VALUE ENGINEERING REPORT

I-95/Horse Stamp Church Road Interchange Camden County

Project No. NH-95-1(167) P.I. No. 511430

February 25, 2009

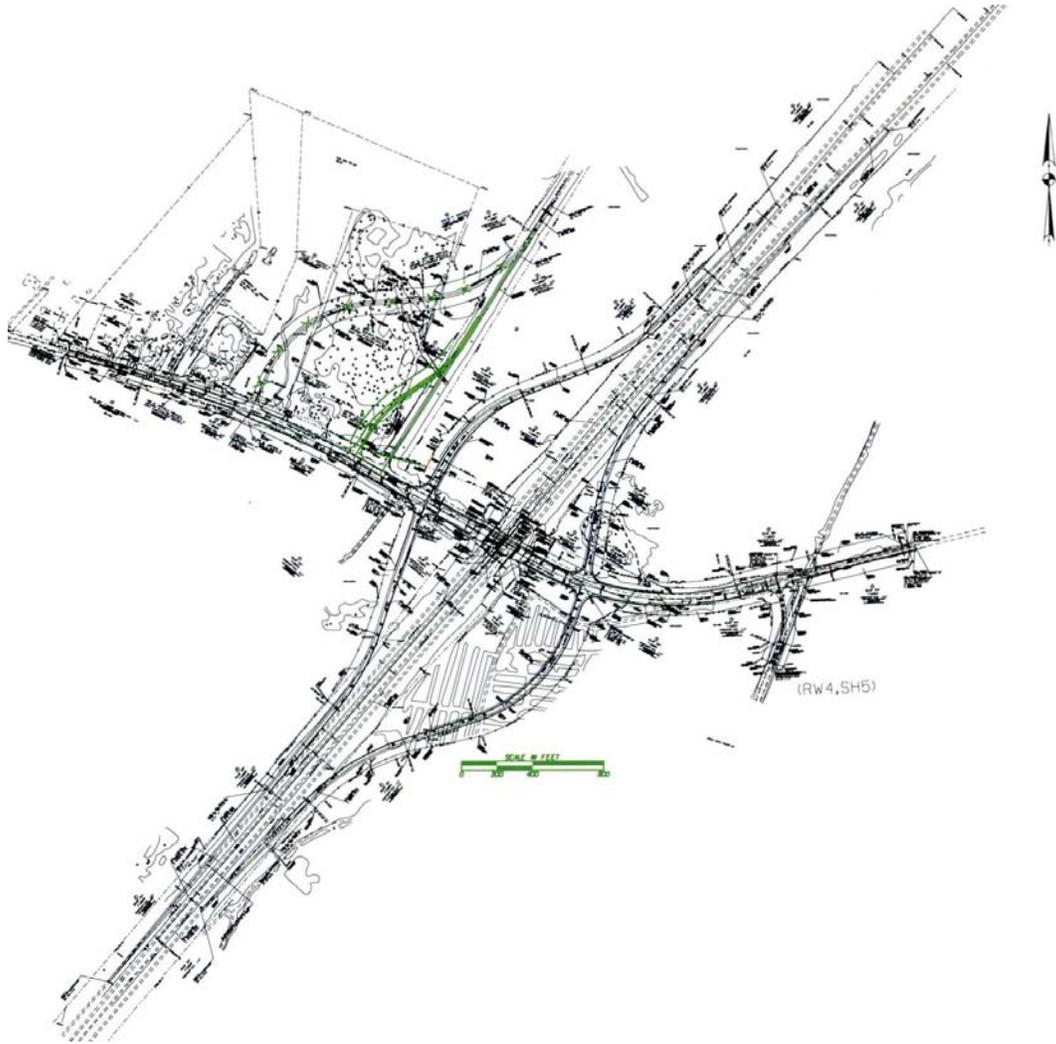
DEVELOPMENT AND RECOMMENDATION PHASE			
Project Name I-95/Horse Stamp Church Rd. Interchange			
IDEA No.: EA-4	Sheet No.: 1 of 4	CREATIVE IDEA: Realign Spring Bluff Road Relocation Intersection	
Prepared By: AW		Date: 02/05/09	Checked By: RHC Date: 02/16/09
Original Concept:			
<p>Realign the Spring Bluff Road intersection with Horse Stamp Church Road approximately 1100' west of the intersection of the southbound ramps with Horse Stamp Church Road. This provides approximately 1000' of limited access from the ramp intersection west.</p>			
Proposed Change:			
<p>The VE Team recommends that the Design Team move the Spring Bluff Road intersection closer to the ramp intersection and allow a minimum of 300' of limited access in lieu of 1000' (See Sketch)</p>			
Justification:			
<ul style="list-style-type: none"> -The length of the relocation would be shorter, thus reducing its construction and O&M costs. -Impact on wetlands and property would be reduced. . -A box culvert would be eliminated. -The required length of reconstruction on Horse Stamp Church Road would be reduced -Separation of ramp termini and local road intersection of 300' meets applicable standard. 1000' separation, although desirable, is not required in this condition.

IDEA No:
EA-5

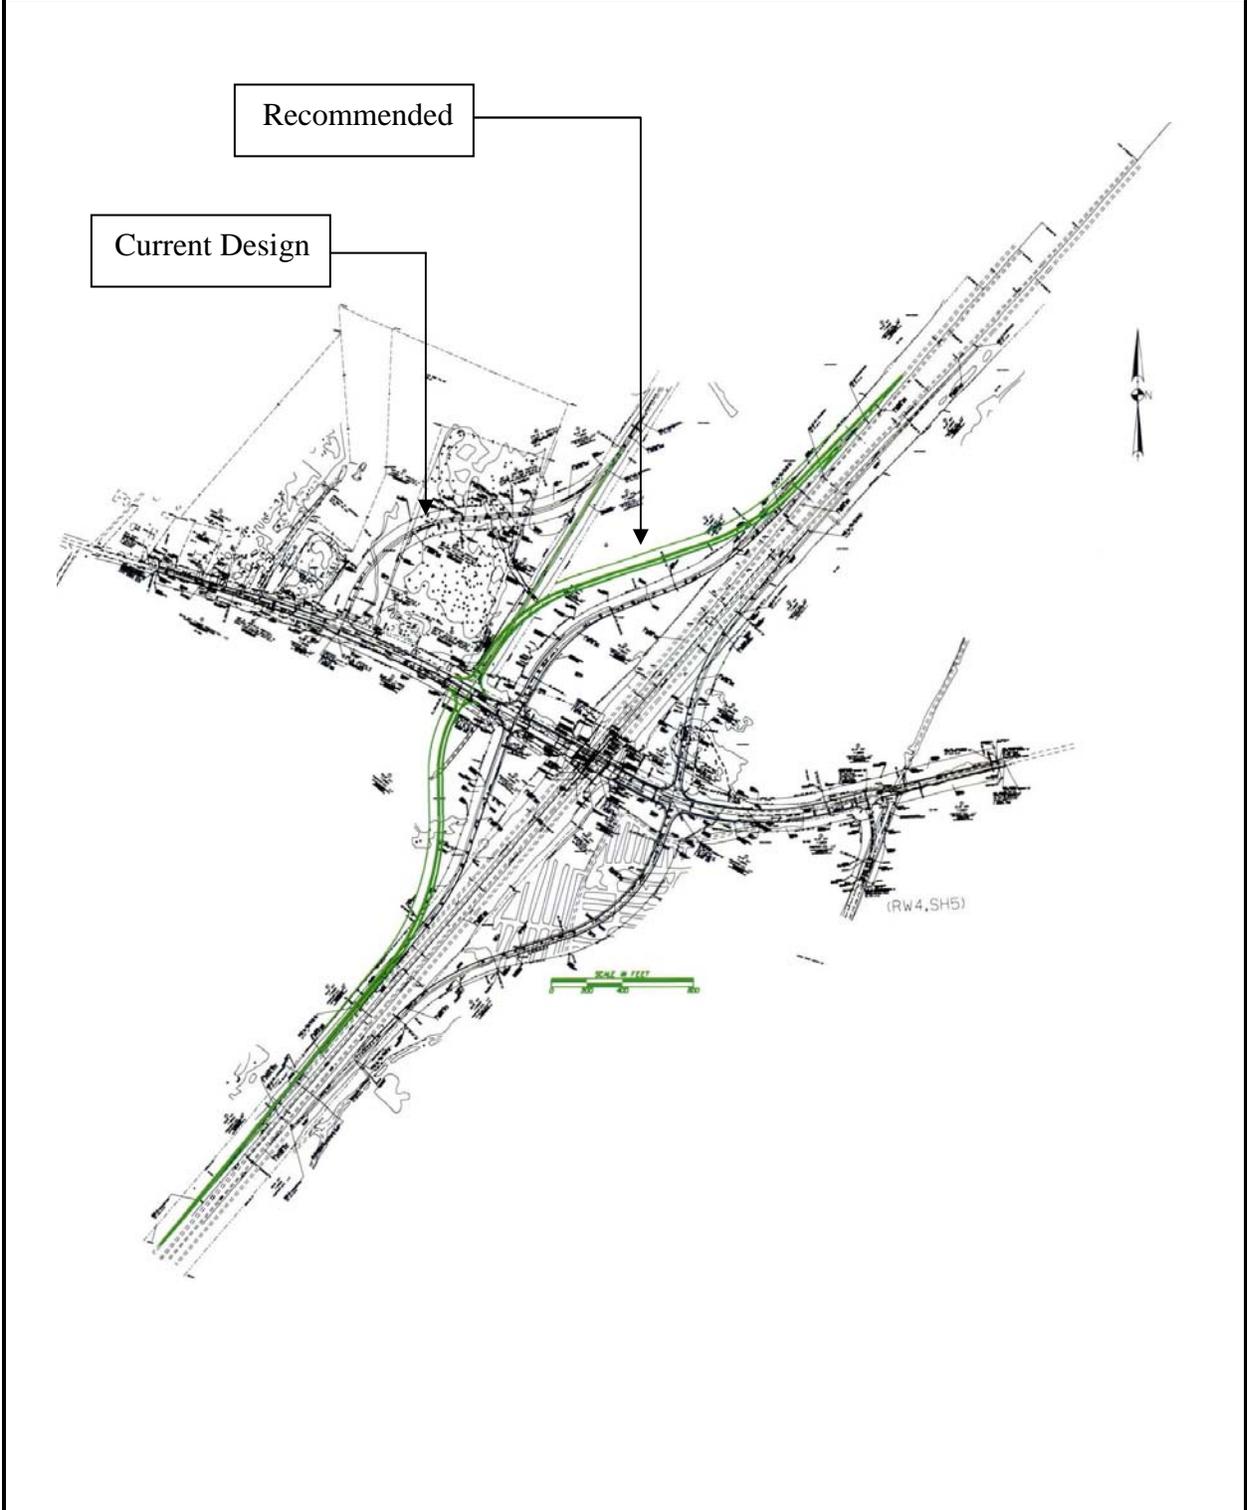
DEVELOPMENT AND RECOMMENDATION PHASE			
Project Name I-95/Horse Stamp Church Rd. Interchange			
IDEA No.: EA-5	Sheet No.: 1 of 4	CREATIVE IDEA: Realign the Southbound Exit Ramp Onto the Original Spring Bluff Road Alignment	
Prepared By: AW Date: 02/05/09 Checked By: RHC Date: 02/16/09			
Original Concept:			
The current southbound exit ramp intersects Horse Stamp Church Rd. approximately 300' east of the existing intersection of Spring Bluff Rd. The current alignment will impact several wetland areas before intersecting with Horse Stamp Church Road.			
Proposed Change:			
The VE Recommendation is to realign the southbound entrance and exit ramps so that the exit ramps align with the current alignment of Spring Bluff Rd. at Horse Stamp Church Rd. (See Sketch) Note: This recommendation is mutually exclusive with Recommendation EA-4			
Justification:			
Although the proposed alignment would increase the project construction cost, it would avoid wetland areas between Spring Bluff Rd. and I-95. The additional cost may be acceptable to the design team in order to gain this advantage. This recommendation would reuse some of the existing Spring Bluff roadbed.

IDEA No:
EA-11

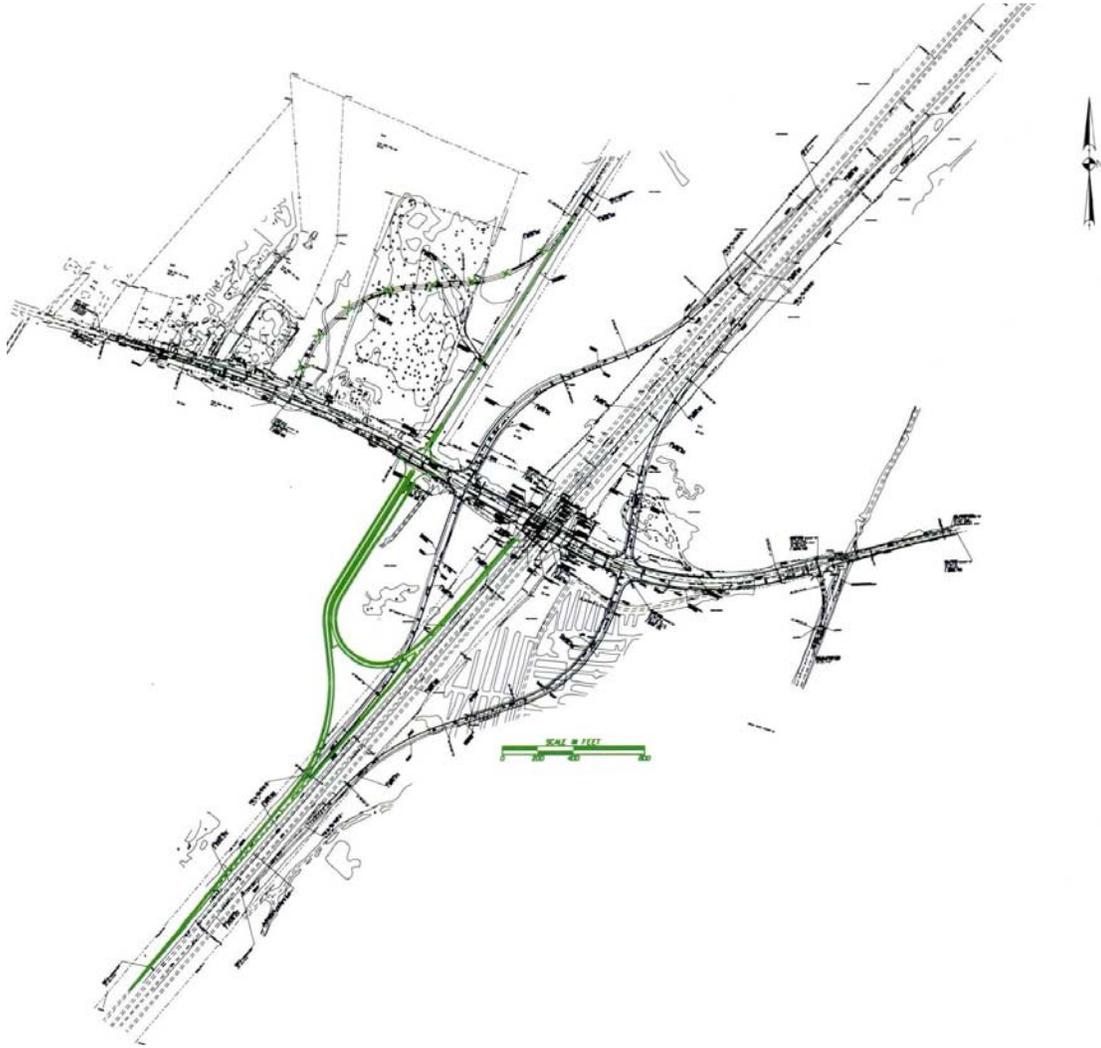
DEVELOPMENT AND RECOMMENDATION PHASE			
Project Name			
I-95/Horse Stamp Church Rd. Interchange			
IDEA No.:	Sheet No.:	CREATIVE IDEA:	
EA-11	1 of 5	Provide loop ramp for southbound exit ramp	
Prepared By: AW		Date: 02/04/09	Checked By: RHC Date: 02/16/09
Original Concept:			
<p>The baseline concept calls for providing a full diamond interchange and relocating Spring Bluff Road away from the new SB ramps.</p>			
Proposed Change:			
<p>The VE Team recommends a loop ramp for the southbound I-95 traffic to Horse Stamp Church Rd. The proposed southbound entrance would be moved over to accommodate the loop ramp. The new onramp and offramp would align with the existing Spring Bluff Road, creating a two-way intersection. (See Sketch) Note: This recommendation is mutually exclusive with Recommendations EA-4 and EA-5 above.</p>			
Justification:			
<p>The loop ramp would eliminate the current southbound exit ramp which impacts a wetland and causes the 2200' relocation of Spring Bluff Road. By eliminating the Spring Bluff Road relocation, a fairly large wetland encroachment would be eliminated as well as any possible impacts to the cemetery. This change would also avoid splitting the Daniels property with the proposed relocation. Additionally, this recommendation would avoid another wetland where the currently proposed exit ramp will traverse. The loop ramp would likely have a lower design speed but would be acceptable for this location and traffic volume. This change would reduce construction cost significantly. It would also eliminate a future signal.</p>

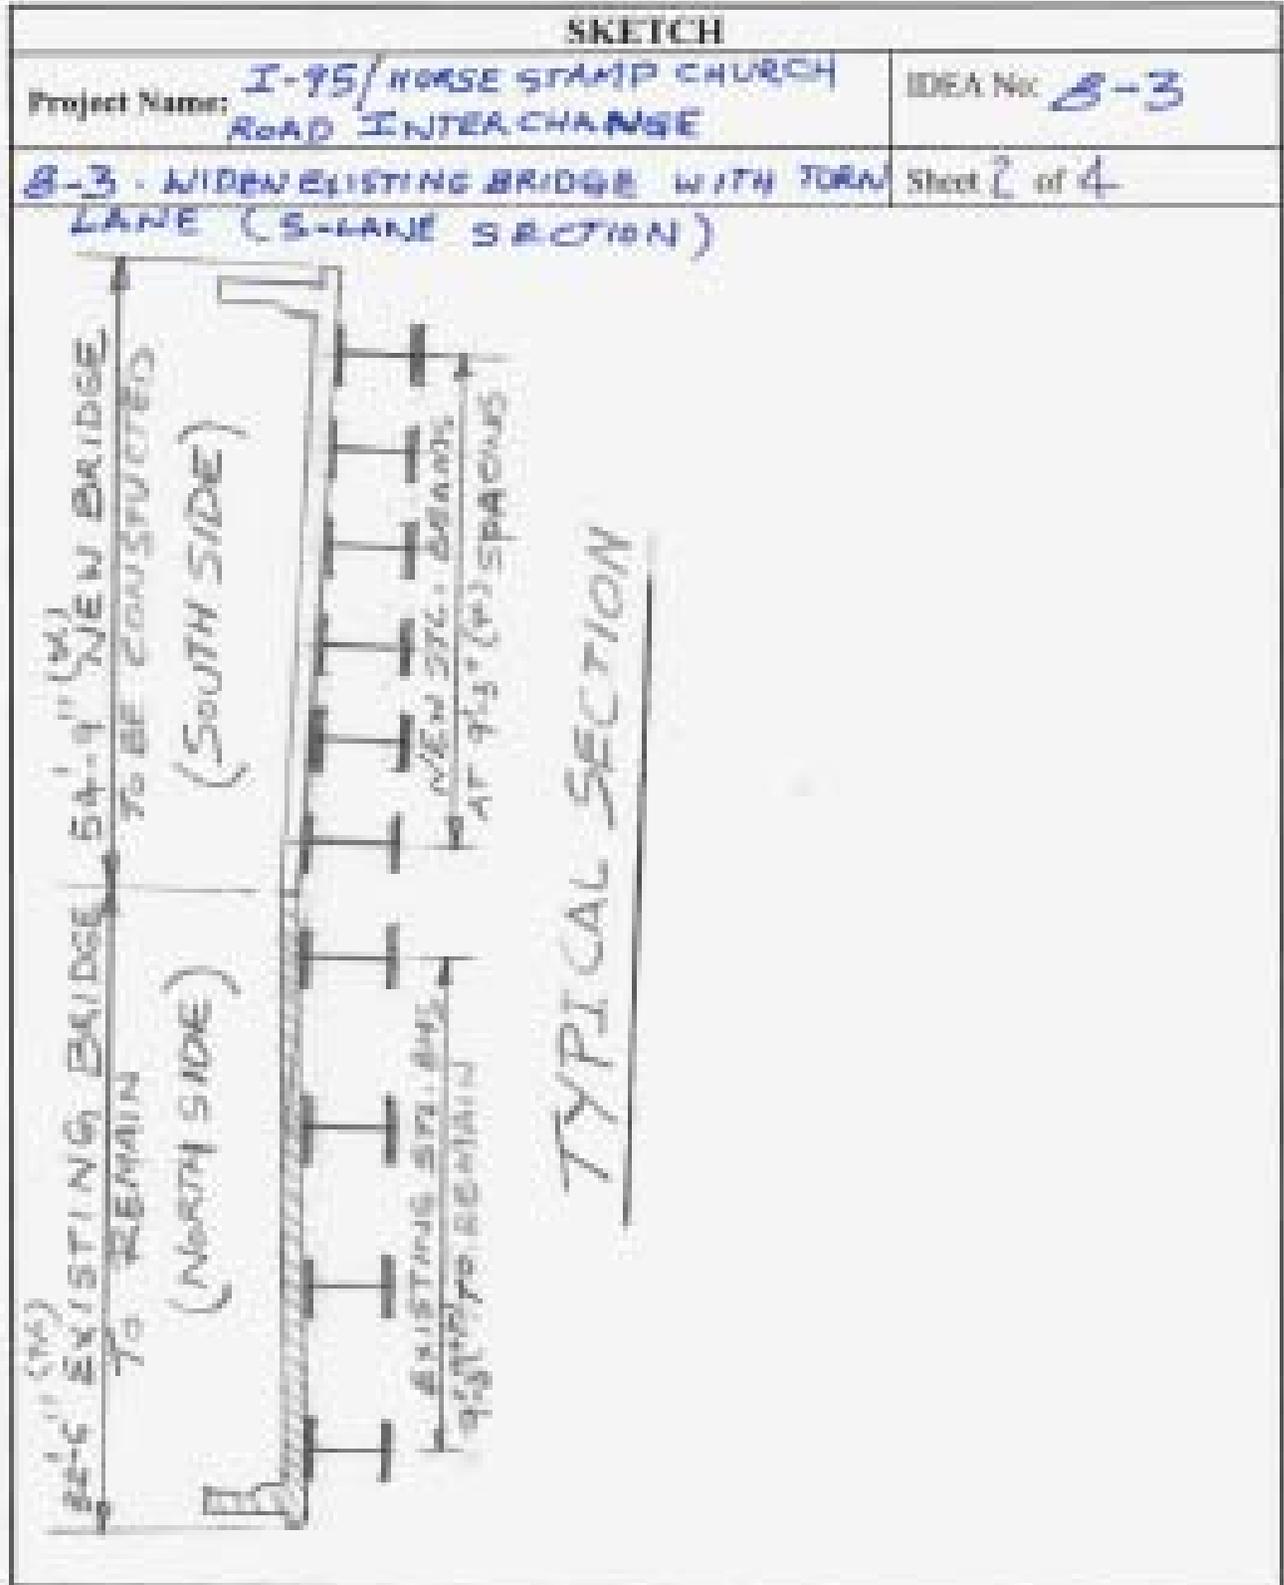
DEVELOPMENT AND RECOMMENDATION PHASE			
I-95/HORSE STAMP CHURCH ROAD INTERCHANNNGE			
IDEA No.: B-3	Sheet No.: 1 of 4	CREATIVE IDEA: Widen Existing Bridge	
Prepared By: AS		Date: 2/5/09	Checked By: RHC Date: 02/16/09
Original Concept:			
The baseline concept is to replace the existing two lane structural steel bridge with a new 5-lane pre-stressed concrete beam bridge.			
Proposed Change:			
The VE Recommendation is to widen the two-lane existing structural steel bridge to a five lane section.			
Justification:			
The existing bridge has a sufficiency rating of 78, indicating a significant useful life remaining. This recommendation would retain this resource.			
Widening the existing bridge would be feasible, particularly given the fact that the Horse Stamp Church Road will be closed during construction.			
This change would yield a significant construction cost savings, including a reduction of required bridge length of 28'.

The cost of removing the existing bridge (not included in estimate or this recommendation) would be avoided..			
LIFE CYCLE COST SUMMARY	CAPITAL COST	FUTURE COST	TOTAL COST
INITIAL COST - Original	\$2,650,000
